PRODUCT IMPROVEMENT BULLETIN # 24

PRODUCT: HR5100, HR6100 & HR6140 Injectors

REFERENCE: Loadcell Weight Readout Oscillations

Figure 1 Roller Locations

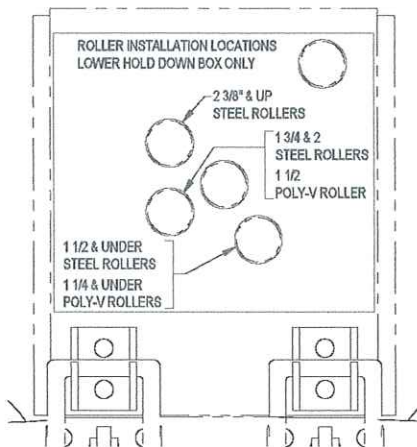
Hydra Rig NOV is aware of HR6100 weight gauges showing oscillating readouts when running 2 3/8" tubing or larger in some cases. A solution has been found that improves the oscillation of the readout with only minor changes to equipment setup. In addition to the solution below, the following conditions must also be met: proper loadcell adjustment, tubing guide alignment, coiled tubing line pull and injector guying.

Solution: Install the new tubing guide roller position label (CB363757) covering the holes as shown in figure 1 below on the hold down box closest to the injector. Follow the roller position installation on the label to allow the tubing to move freely up and down due to the curves in the coiled tubing.
